Access Compliance Report

Public Rights-of-Way

(Curb Ramps)

Intersection ID: 5752	Main Street: DELLINGER_CR	Cross Street: MILHAVEN_LN	Location: SW
ADA ID: 76AD3912BB53	Ramp Type: Perp	Initial Pass/Fail: Pass	Overall Compliance: No
		Severity Score: 7.5

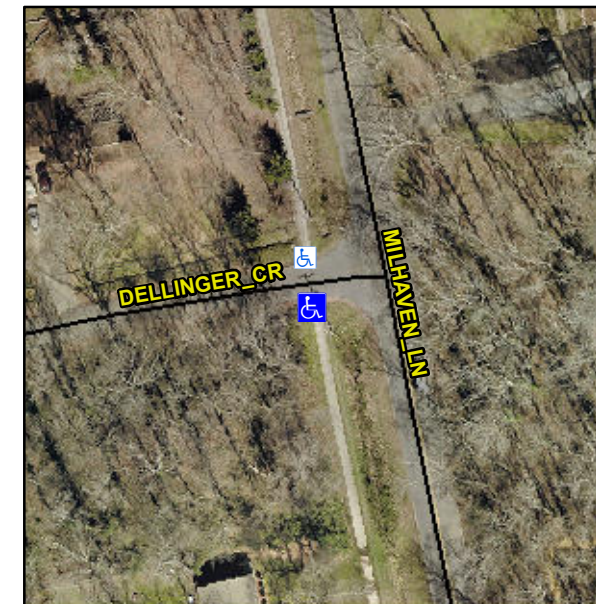
R304.2.2-Perp, R304.3.2-Para,
R304.5.3, R305.1.4, R305.2, R304.5.4

Compliance	Description	Data	Compliance	Description	Data
N/A	Ramp Length (in)	36.0	Yes	Ramp Slope (%)	8.2
Yes	Ramp Width (in)	59.5	Yes	Ramp XSlope (%)	1.6
N/A	Flare Type LT	None	N/A	Flare Type RT	N/A
N/A	Flare Slope LT (%)	N/A	N/A	Flare Slope RT (%)	N/A
N/A	Flare Traversable LT?	N/A	N/A	Flare Traversable RT?	N/A
Yes	Landing Length (in)	48.0	Yes	DWS Provided?	Yes
Yes	Landing Width (in)	59.5	Yes	DWS Contrast?	Yes
No	Landing Slope (%)	7.7	Yes	DWS Length (in)	24.0
No	Landing X Slope (%)	2.6	No	DWS Full Width?	No
N/A	Landing Curb? (Y/N)	No	No	DWS Offset (in)	12.0
N/A	Shared Landing?	No			
Yes	Gutter Ponding?	No	No	Gutter Slope (%)	6.9
Yes	Gutter Lip Ht (in)	0.0	No	Gutter X Slope (%)	2.5
N/A	Painted X Walk1?	No	N/A	Painted X Walk2?	N/A
	X Walk 1 Direction	To N		X Walk 2 Direction	N/A
N/A	X Walk 1 Width (in)	N/A	N/A	X Walk 2 Width (in)	N/A
	X Walk 1 Slope (%)	8.1		X Walk 2 Slope (%)	N/A
	X Walk 1 X Slope (%)	2.5		X Walk 2 X Slope (%)	N/A

Remove & Replace Entire Ramp.
Remove & Replace Gutter.
